Duke Power Company  
Oconee Nuclear Station

Attachment 1

15 EFPY Pressure/Temperature Limits

Low Temperature Overpressure Protection Technical Justification

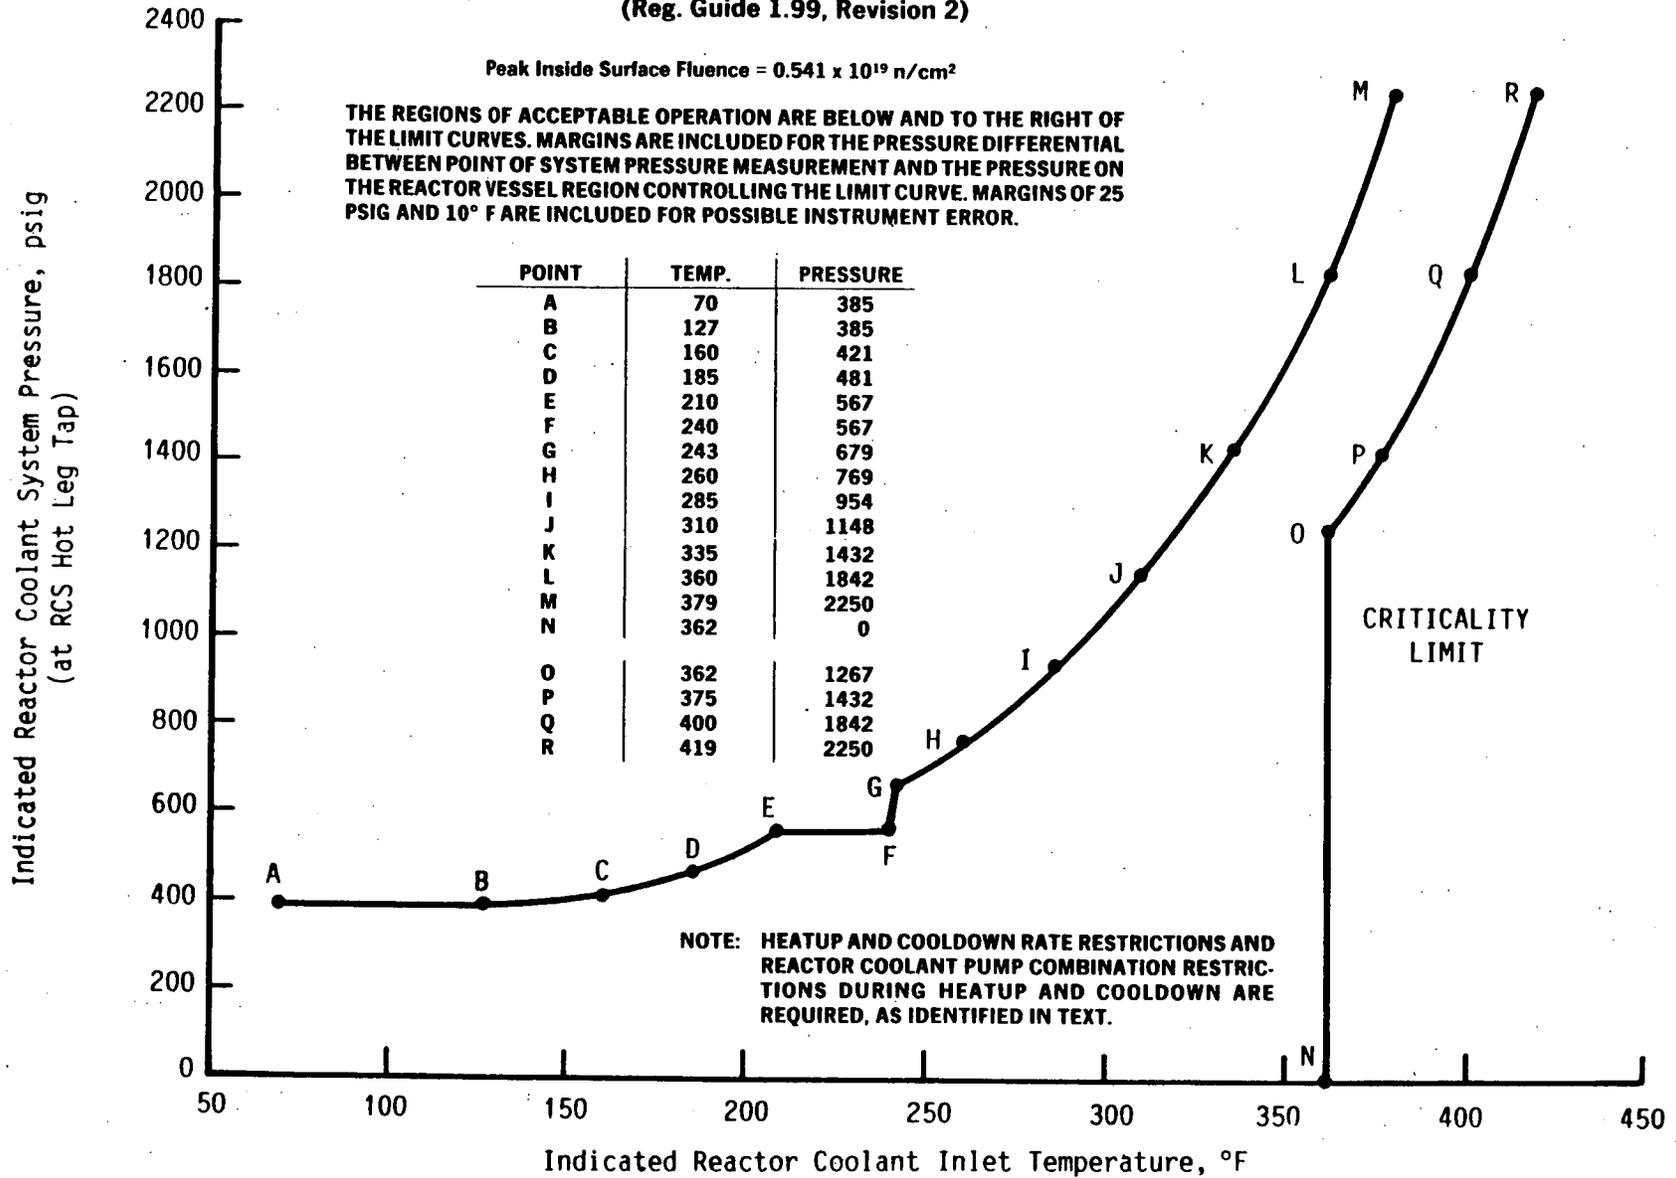
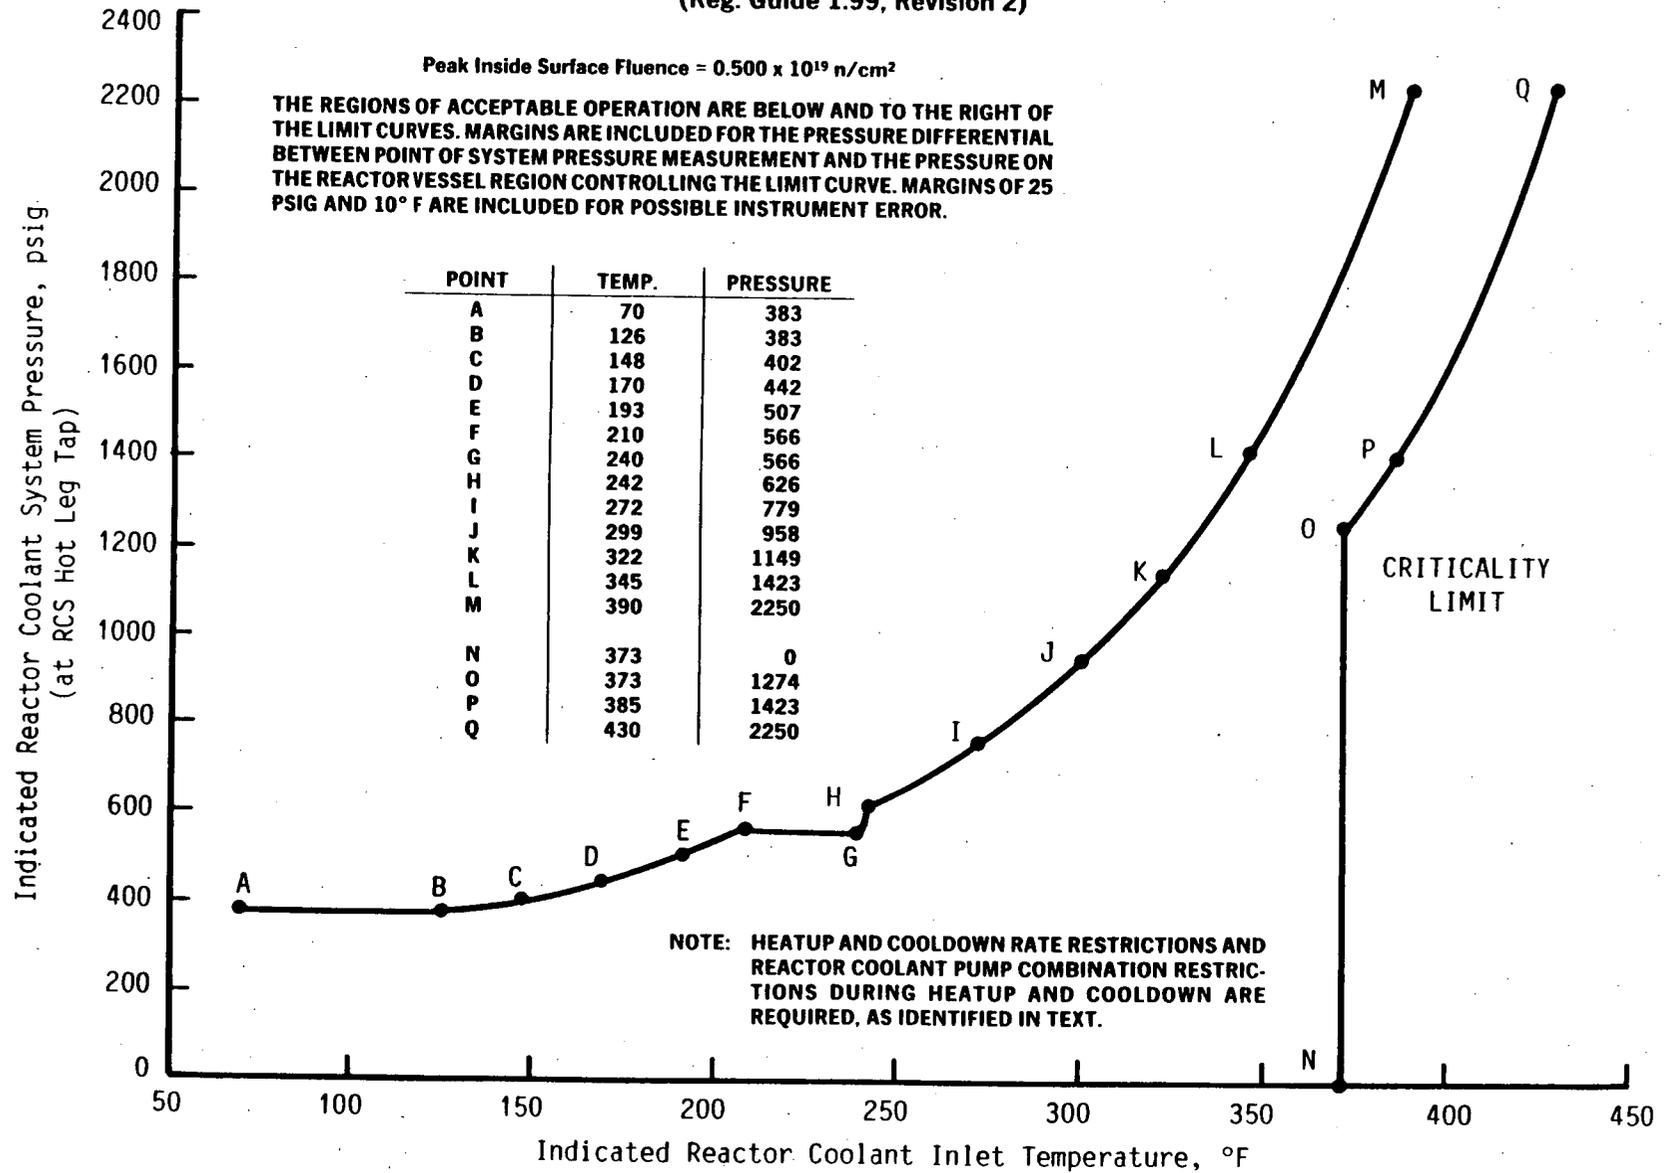
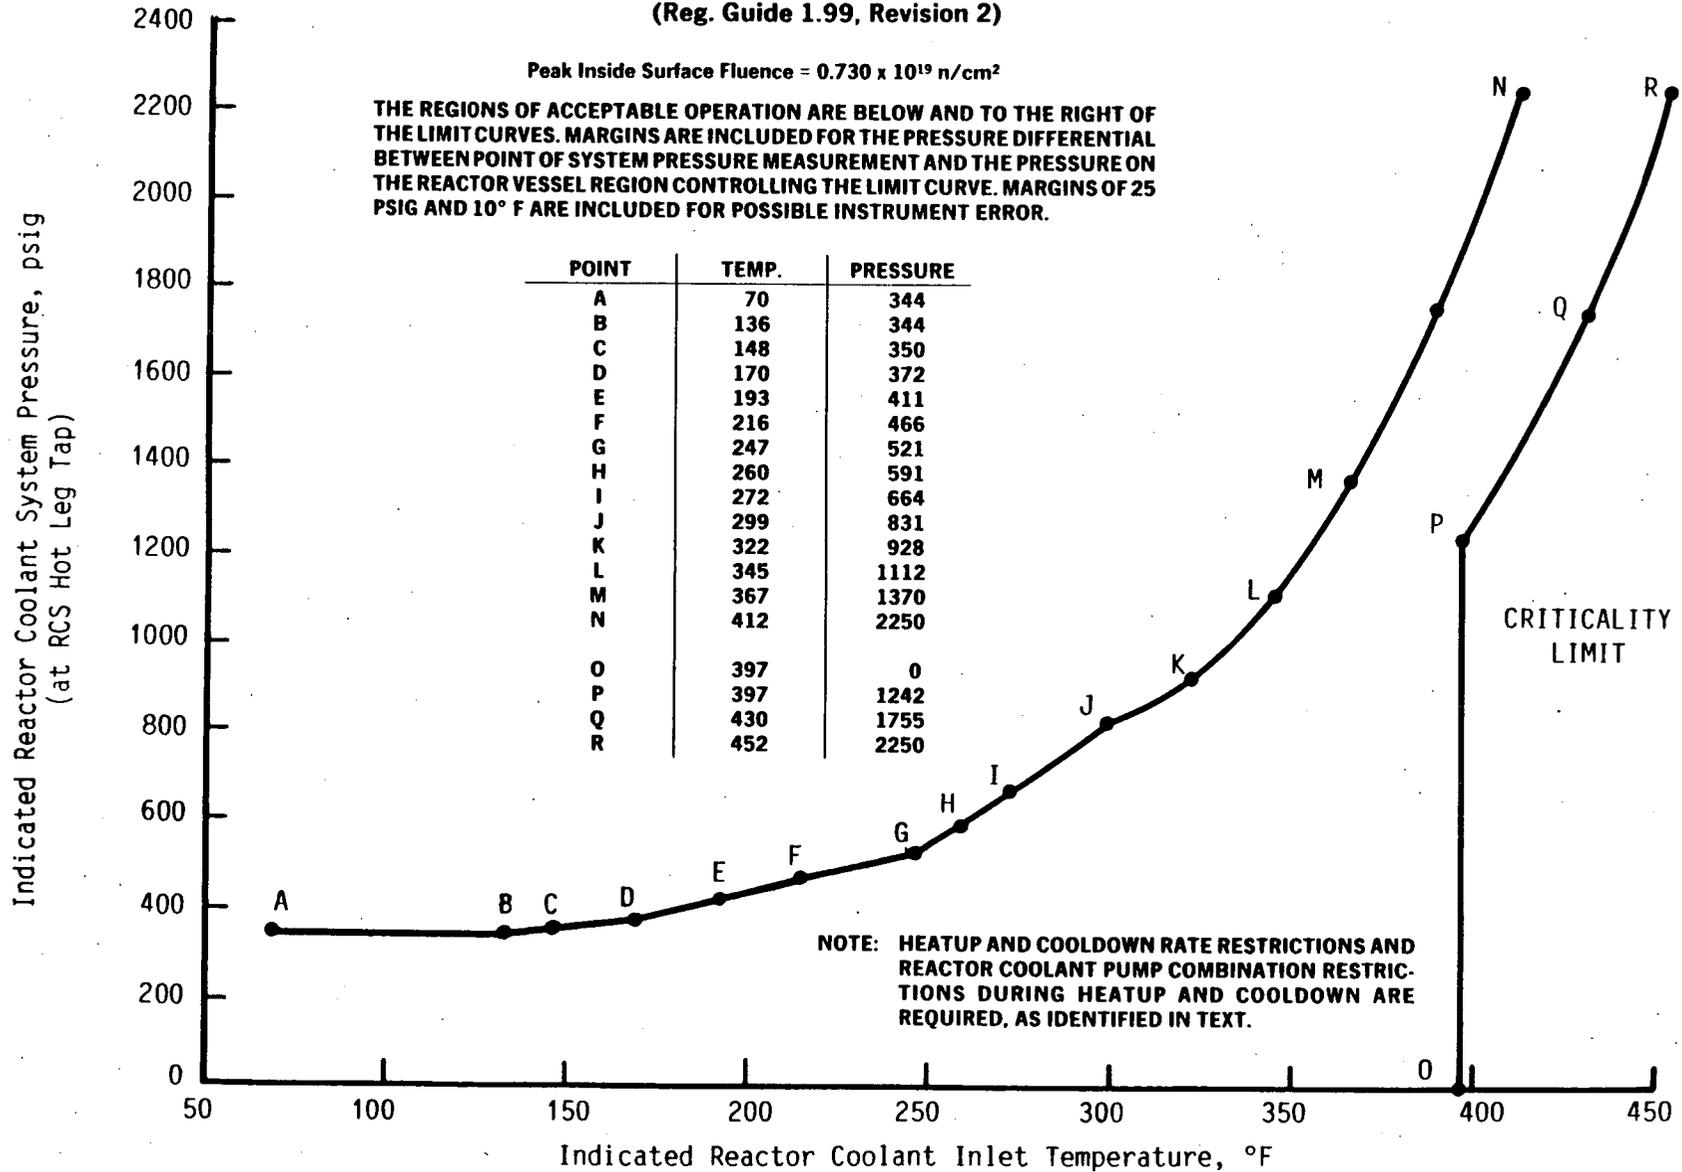
As required by GL 88-11, P/T limits revised in accordance with RG 1.97, Rev. 2 are provided in Figure 3.1.2 (Attachment 1). In addition, operational limits for plant heatup (including additional reactor coolant pump constraints) and cooldown are provided in Tables 3.1-1 and 3.1-2 respectively. The methods and criteria employed to establish operating P/T limits are described in NRC approved topical report BAW-10046A, June 1986. Thus, the revised P/T limits and heatup and cooldown constraints provided in Attachment 1 prevent nonductile failure during any normal operating condition, including anticipated operational occurrences and system hydrostatic tests.

The limit curves for Oconee 1, 2, and 3 are based on the predicted values of the adjusted reference temperature of the limiting beltline region material for each unit at the end of the fifteenth EFPY. The adjusted reference temperatures are calculated by adding the predicted radiation-induced  $RT_{NDT}$  to the initial  $RT_{NDT}$ . The predicted  $RT_{NDT}$  is calculated using the respective vessel's neutron fluence and chemistry. The predicted reactor vessel inside surface peak fluence value at 15 EFPY for each of the Oconee Units is summarized below. Regulatory Guide 1.99, Rev. 2, was used to predict the radiation-induced  $RT_{NDT}$  values as a function of the material's copper and nickel content and neutron fluence. Using these fluence values and the vessel's chemistry, the adjusted  $RT_{NDT}$  values of the beltline region at the end of the fifteenth full-power year are provided below. The adjusted  $RT_{NDT}$  values are given for the 1/4T and 3/4T vessel wall locations ( $T = \text{wall thickness}$ ). The assumed  $RT_{NDT}$  of the closure head region and the outlet nozzle steel forgings is 60F, in accordance with BAW-10046A.
